PREDEVELOPMENT PLAN REVIEW COMMENTS TO APPLICANT

Project Number: PPR2021-00006 **Date:** August 5, 2021
(Revised August 19, 2021)

Project Address: 280 Ramona St. / 279 E. Holly St.

Project Description: Predevelopment Plan Review for a new 5-story 112 unit senior affordable housing project with on-site amenities, semi-public courtyard, and one level of subterranean parking with 44 parking spaces.

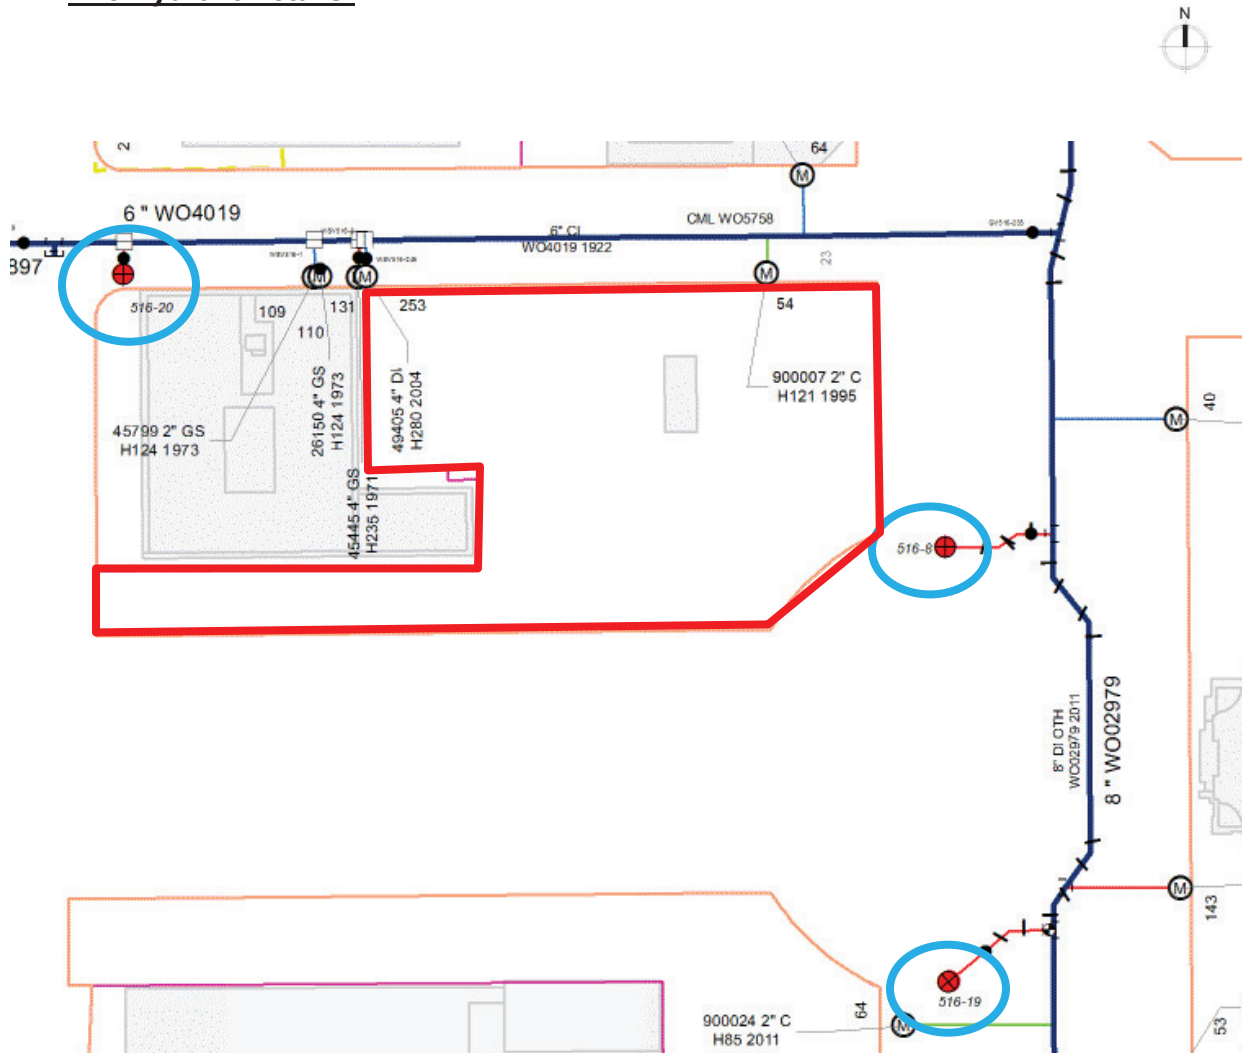
There are three fire hydrants in close proximity to the project site:

- Fire hydrant 516-8 is located on the west curb of Garfield Avenue, approximately 130 feet south of Ramona Street.
- Fire hydrant 516-9 is located on the west curb of Garfield Avenue, approximately 170 feet north of Union Street.
- Fire hydrant 516-20 is located on the southeast corner of Marengo Avenue and Ramona Street.
